**AQUATIC EFFECTS MONITORING PROGRAM 2016 ANNUAL
REPORT – PLAIN LANGUAGE BRIEFING AND TECHNICAL
REVIEW COMMENTS**

Technical Memorandum # 367-17-01

Environmental Monitoring Advisory Board (EMAB)
P.O. Box 2577
Yellowknife, NT
X1A 2P9

May 28 2017

Figure 3.1-1. Dustfall results, Diavik Diamond Mine, 2016. (after Golder 2017)

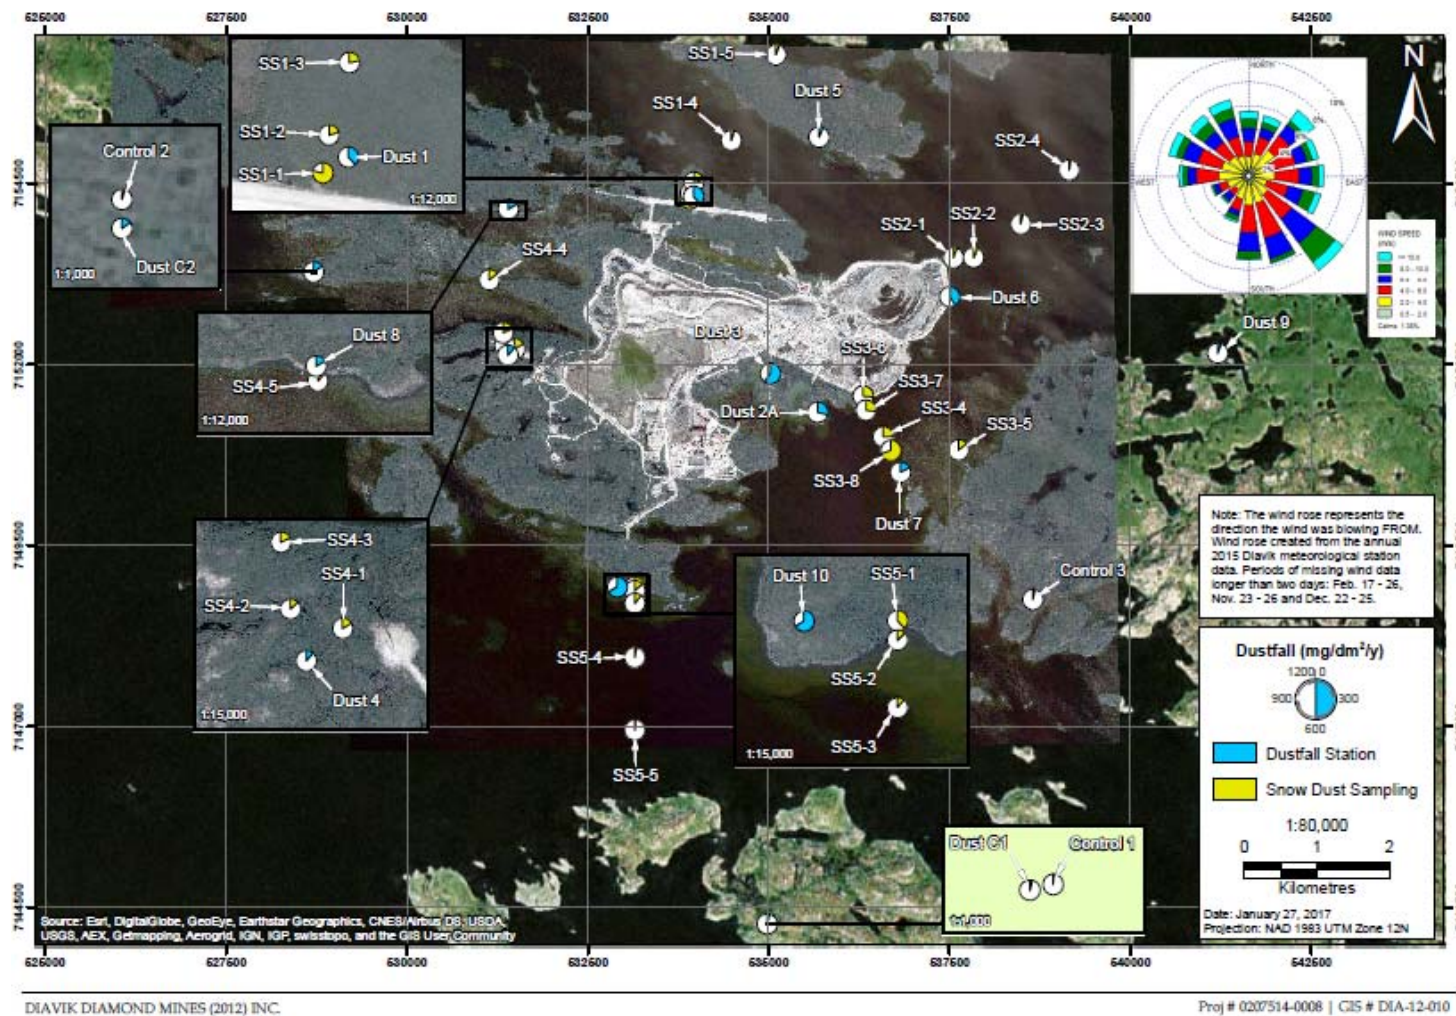
Given the relatively high dust deposition observed at sites south and southeast of the mine, it would be beneficial to add a site between the two monitoring axes (i.e., SSE in the vicinity of the water quality site MF3-3) and a dustfall monitoring station south of site Dust 10 (i.e., at or near one of the snow dust fall sites SS5-4 and SS5-5). See excised Figure 3.1-1 below for reference.

Recommendation: Consider addition of dustfall sites to the SSE of the mine and south of Dust 10.

Figure 3-10. Zooplankton biomass in Lac de Gras and Lac du Sauvage relative to distance from the effluent discharge, 2016. Arrow indicates site NF5. (after Golder 2017)

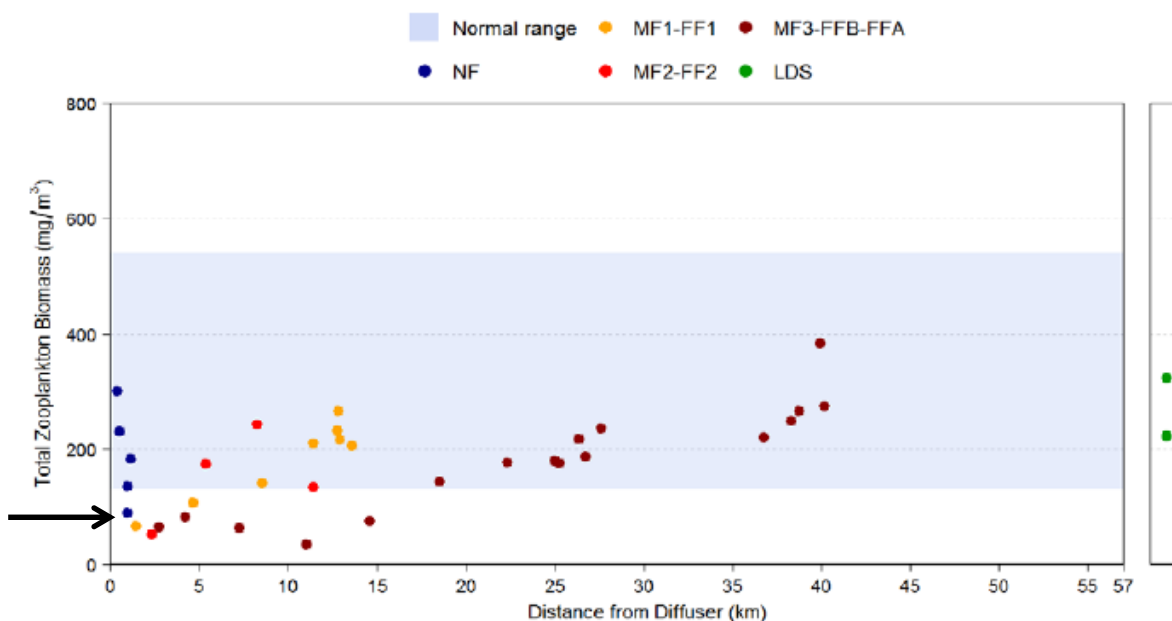
Station NF5 was sampled approximately 2 weeks later (August 30) than the remaining four NF sites (August 15-18). This gap in sampling timing may affect comparability of the water quality, phytoplankton, and zooplankton data for characterizing the NF area. At least two variables were notably different at the NF5 site relative to sites NF1 through NF4; zooplankton biomass (see excised Figure 3-10 below for reference) was below the normal range at site NF5 (Appendix XI Plankton Report, Section 3.2.1.1, page 29) and chlorophyll *a* was highest at site NF5 of all the NF sites (Appendix XIII Eutrophication Indicators Report, Appendix B, page B-25).

Recommendation: Provide a discussion of potential effects related to the later sampling date for NF5 on the dataset and subsequent analyses. Explore the effects of excluding data for site NF5 on data analyses and comparisons among sampling areas and modify if appropriate.

Figure 3-24. Specific conductivity profiles at MF2 Transect Stations, 2016. Circle denotes higher specific conductance values in the lower part of the water column in winter at NF sites (after Golder 2017)

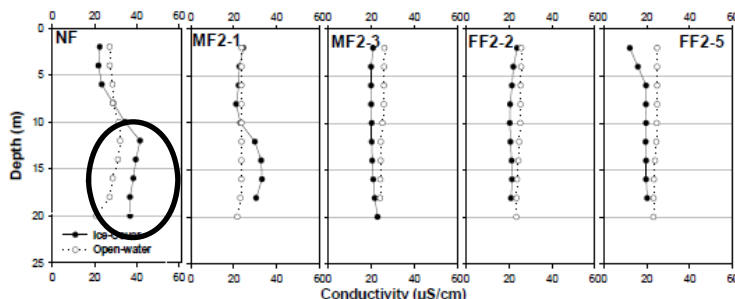
Medians of water quality parameters in the NF area were calculated from data pooled across all sample depths, dates and stations (n = 15 samples; Appendix II, Section 3.4.1, page 64, Table 3-5). When water quality is relatively consistent across depth this approach is reasonable and appropriate. However, in instances where conditions vary across the water column such as in winter when the effluent plume is more evident near the bottom of the water column, it may be more conservative to examine data for each sampling depth separately. If effects are greatest near the bottom of the water column, potential effects on benthos would be better represented by the bottom water quality samples. See example Figure 3-24 below for reference.

Recommendation: Consider analysing NF water quality data by sampling depth for deriving median concentrations for comparison to action levels.

Figure 4-2. Total nitrogen affected area in Lac de Gras, 2016. (after Golder 2017)

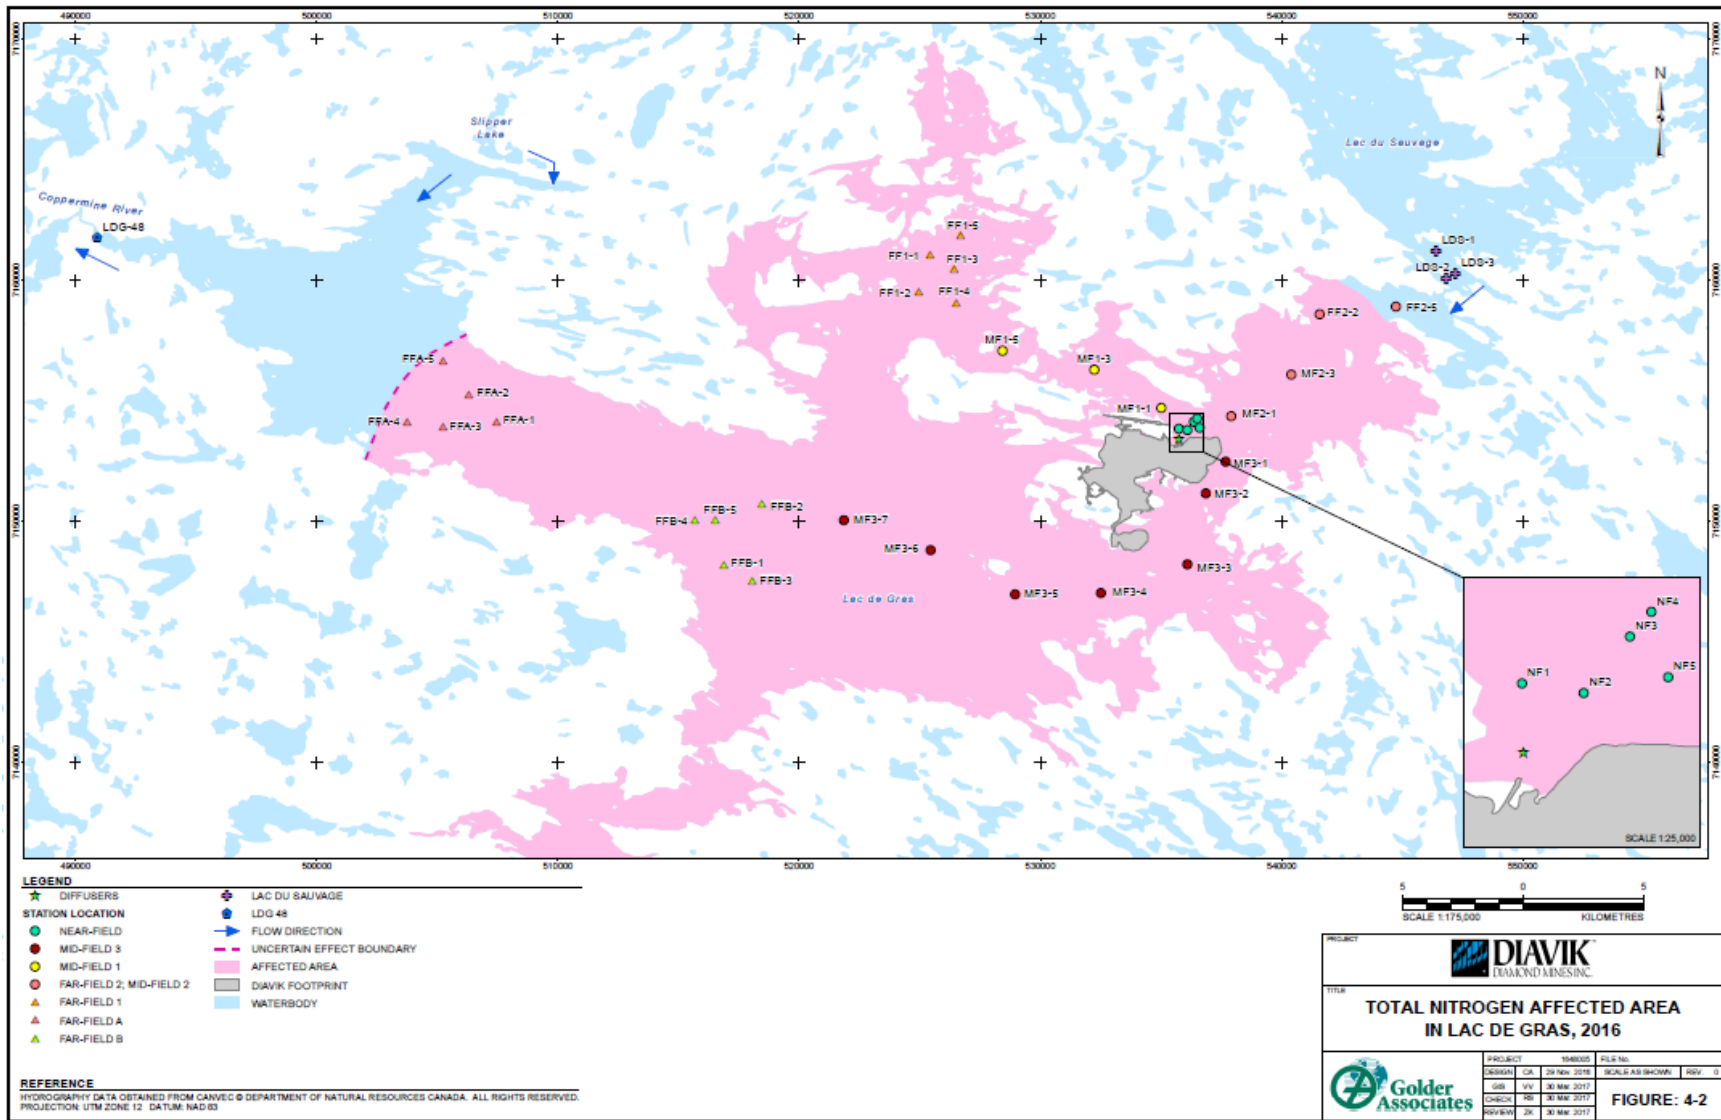
Comment 1: Section 2.1.2 of Appendix XIII (page 5) indicates that no sample was collected from LDG-48 (the outlet of the lake) in the open-water season. As a result the spatial extent of effects on total nitrogen and cumulative effects were not assessed for the northwest area of the lake beyond sites FFA-4 and FFA-5 (see Figure 4-2 below for reference).

While it is understood that sampling methods employed in the water quality monitoring program are not consistent with those for the eutrophication monitoring program, the TN concentration measured at LDG-48 in August, 2016 (174 µg/L) under the water quality program was above the normal range (122-153 µg/L) for the open-water season. Based on this measurement, the spatial extent of effects extended through the northwest portion of the lake (i.e., effectively 100% of the lake area).

Comment 2: Regardless of the above consideration, the spatial extent of effects for TN increased notably in 2016 relative to previous years. The spatial extent of effects on chlorophyll *a* was also highest in 2016. Given these potential "trends" and observations, increasing the frequency of FF sampling for the eutrophication metrics to annually rather than every three years seems warranted.

Recommendation 1: Incorporate data collected at site LDG-48 during the water quality monitoring program into the eutrophication analyses and reporting and update maps and spatial extent of effects estimates.

Recommendation 2: Consider increasing the frequency of FF sampling for eutrophication metrics to annual and/or provide a rationale for what actions would be taken in the event that the spatial extent of effects on eutrophication metrics extended up to the MF sites in years when FF sampling is not conducted.

Figure 3-41. Concentration of total silicon at AEMP stations relative to the normal range and action level criteria, 2016. (after Golder 2017)

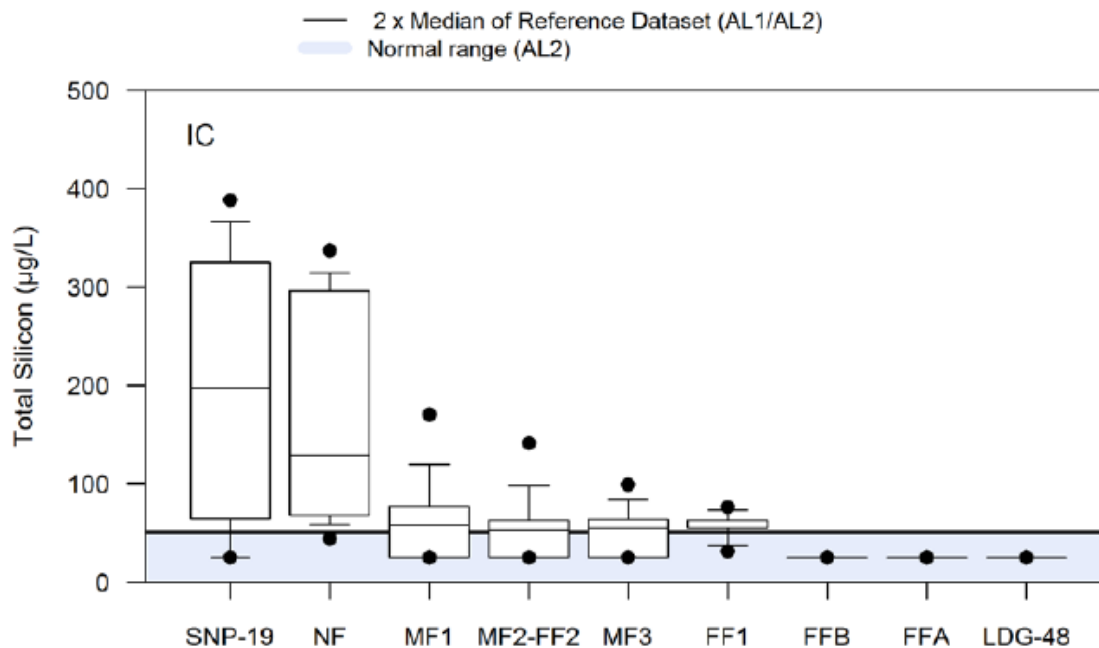
In addition, Appendix XI, Plankton Report, Section 4.1 (page 37) points out that the higher abundance of diatoms observed in the NF area in 2016 may reflect increased concentrations of silica as a result of effluent discharge (see Figure 3-41 below for reference). However, Table 2-2 in Appendix XV, Weight-of-evidence Report (page 8), only identifies nitrogen and phosphorus in water as exposure endpoints in relation to lake productivity.

Recommendation: Include a summary of key supporting variables, including but not necessarily limited to Secchi disk depth, water temperature, and silica within the discussion of results regarding phytoplankton data in the relevant sections of the report.

Figure 3-10. Zooplankton biomass in Lac de Gras and Lac du Sauvage relative to distance from the effluent discharge, 2016. Circle indicates sites MF3-1 through MF3-5. (after Golder 2017)

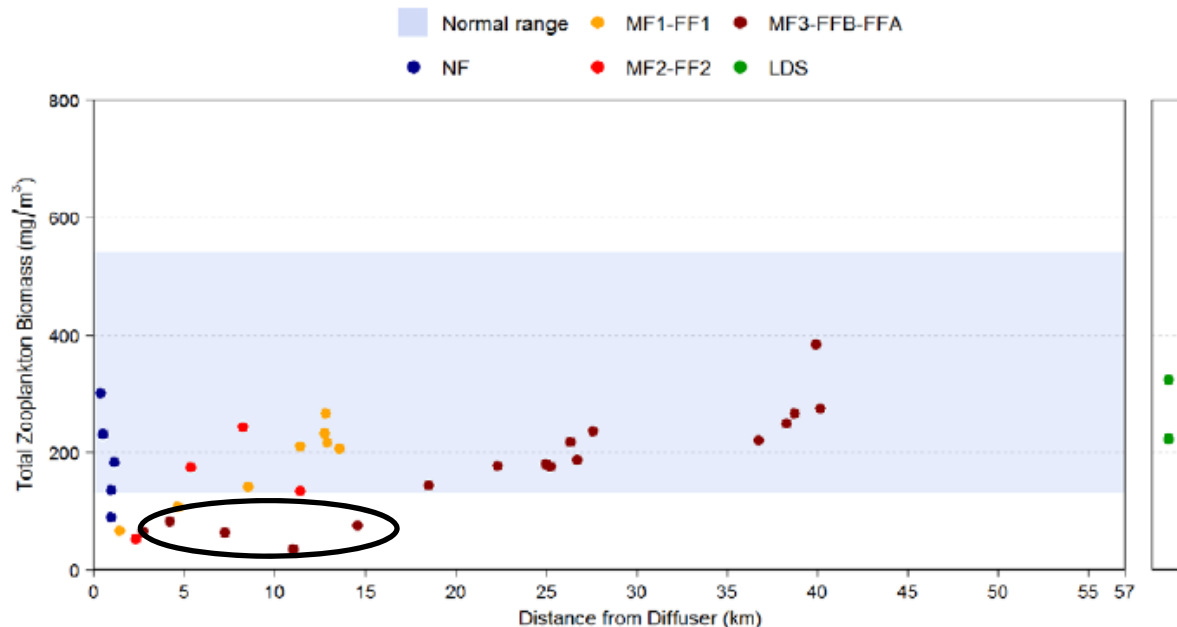
Zooplankton biomass, particularly calanoid copepod biomass, was below the normal range at sites MF3-1 through MF3-5 (see Figure 3-10 below for reference). These results could indicate a potential effect of dust deposition and/or dike construction on zooplankton and should be explicitly discussed, including within the Action Level response discussions.

A comparison of MF data to FF data with and without data for MF sites known to have been affected by dust and/or dike construction would be useful to try and isolate effluent effects from other pathways.

Recommendation: Expand discussion to incorporate dust deposition and dike construction effects on plankton. Compare MF and FF data with and without MF data for sites affected by dust deposition and/or dike construction.
